BOM P/N	Description
*	Origins IO Board

PROJECT : ZHR

Size	Document Number	Rev
	USB 2.0	1A
Date:	Monday, September 14, 2015	Sheet 4 of 5

Lid Switch (HSR)

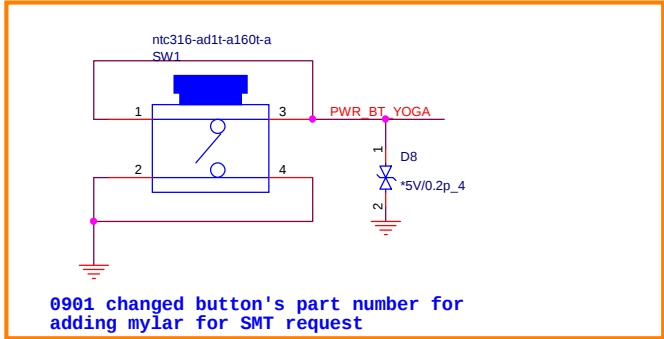
Model	REV	CHANGE LIST	MODEL	
			FROM	To
ZHR/ZHRA	1A	01/02 A01 Changed HSR to EM-1791 for Yoga type (Page 3) A02 Changed Yoga button to slide type(Page 3) A03 Added ESD protector for Dongle issue (Page 4) A04 Level shifter of AJACK_MICPRES_L_227 is moved to MB (Page 5) A05 made connections of I2C_DAT/CLK/INT to MB (Page 5)		
		01/07 A06 corrected ORCAD library of MR1(Page 3)		
		01/08 A07 changed back push button type(Page 3)		
		01/15 A08 Swapped USBP/N on CN3 for layout(Page 3) A09 Added Holes (Page 3) A10 Added option hall sensor called GMR, stuffing GMR(MR2) for yoga SKU(ZHRA), stuffing hall sensor (MR1) for clamshell mode(ZHR) (Page3) A11 changed C25 from 100uF to 220uF(Page23)		
		01/18 A12 Corrected QPN of GMR (Page3)		
		01/19 A13 changed the connector from 30 pin to 34 pin, and added back connection for USB charger(Page 3) A14 updated footprint of GMR (Page 3) A15 added back USB charger(Page 4)

04/27 C04 changed QPN of MIC SW(Page 5)		
		05/06 C05 NC pin35 of Daughter board CONN(Page 3) C06 changed Hall sensor from EM1791 to General hall sensor for ZHR(Page 3)		
	3C	07/06 D01 Added option resistors on LID_OPEN_OUT2_L_CONN for MIC detection issue, R69 is unstuffed(Page 3) D02 unstuffing R991,C575,R307 due to no use on LID_OPEN_OUT2 in convertible device(Page 3) D03 Added option nets on power of 227, stuffing R140 as default(Page 4)		
		07/09 D04 Changed power button for reliable test (Page 3) D05 Changed Footprint of removing mylar for factory side requestPage 3)		
		07/16 D06 Added PAD1-4 as ESD protection(Page 4)

USB Charger(UB2)

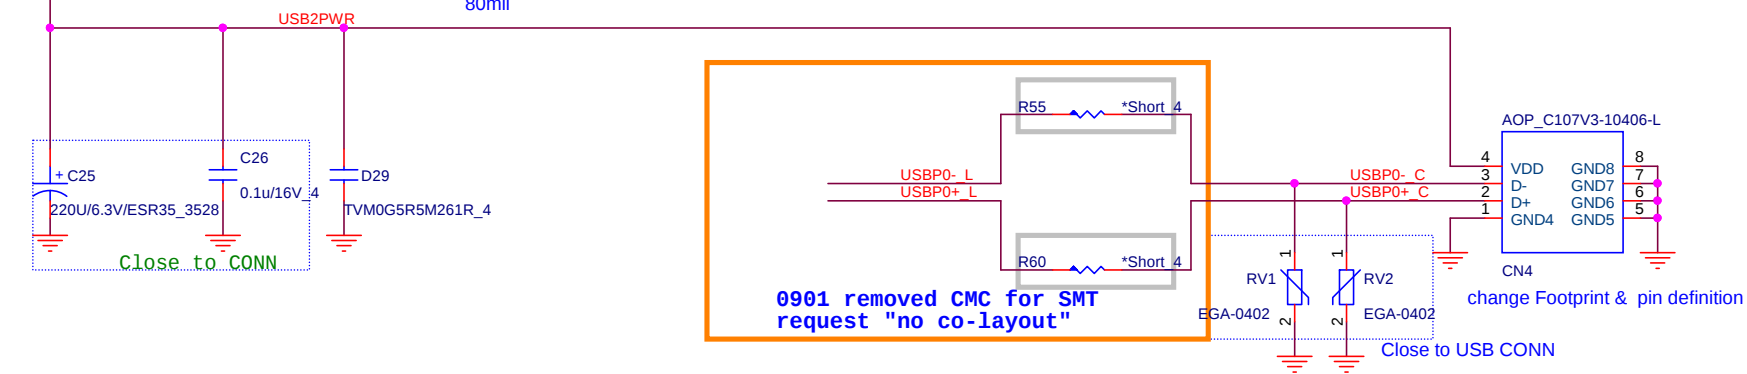
01/20 A16 Added Holes(Page3) A17 Changed QPN of USB charger IC (Page 4) A18 swapped pin of L7 for layout(Page 4) A19 changed QPN of C17 (Page 5) A20 changed footprint of Audio jack(Page 5)		
		01/21 A21 corrected SW1 pin(Page3)		
		01/23 A22 Changed QPN of C26,C27 (Page 4)		
	3A	03/04 B01 changed the pullup on LID_OPEN_OUT1_R_L/LID_OPEN_OUT2_R_L to 100K(Page 3)		
		03/05 B02 for DVT build, changed power side button to DIP type (Page 3)		
		03/09 B03 unstuffed USB charger related componenets (Page 4) B04 Added option 0E, default stuff them for non-USB charger (Page 4) B05 added back USB power switch as default stuffed(Page 4)		
		03/10 B06 Changed Hoile1 footprint and added hole4		
		03/12 B07 Changed C27 to 1uF(Page 4) B08 Added Holes (Page 3) B09 Changed back(unstffed R992/R994/R993/R995,U7,C576to USB charger support (Page4)		
	3B	04/20 C01 adjusted pin mapping of audio signals for adding one more GND, made ADOGND_R option on the pin of PP3300_DSW ,default on pin19 is power pin(Page 3) C02 stuffed RV1/RV2 as ESD diode for protecting USB data line(Page 4) C03 added option on USB_CTL_PWR for one more AGND added if recording noise isn't fixed(Page 4)

Combo Jack (ADO)

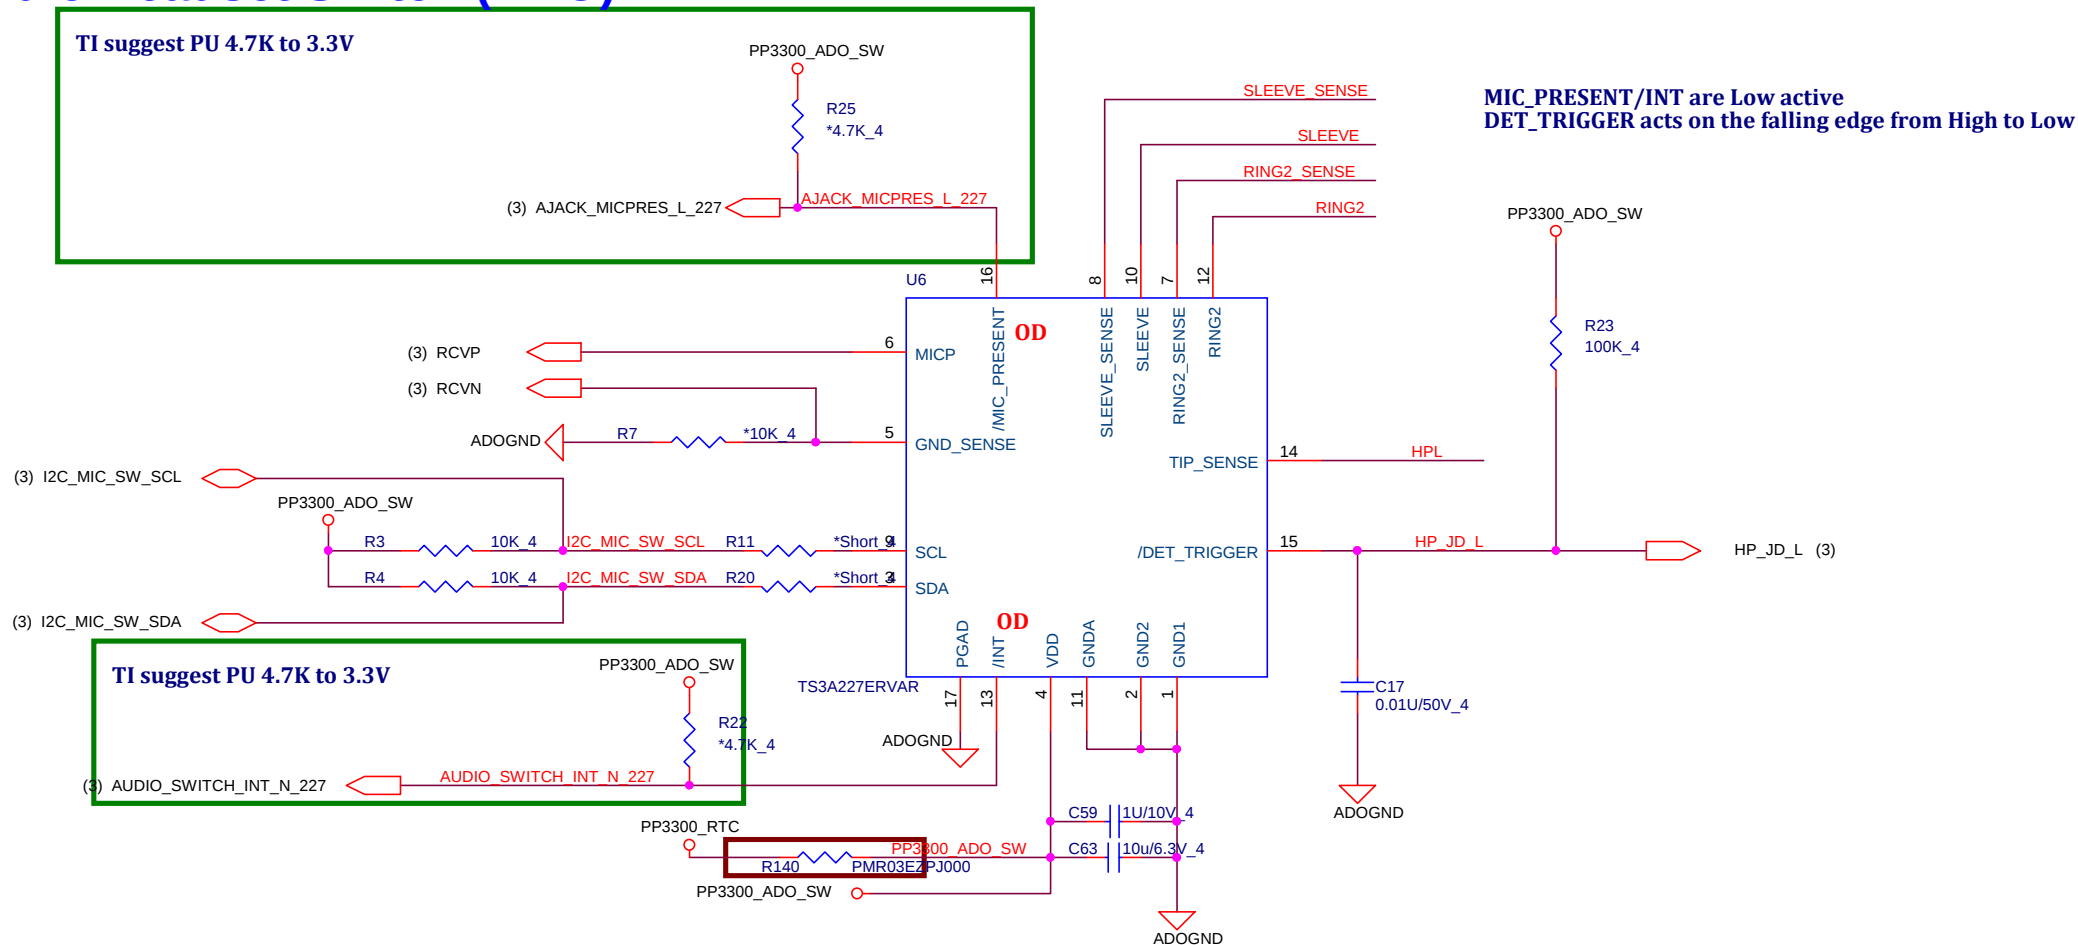
TI suggest PU 4.7K to 3.3V
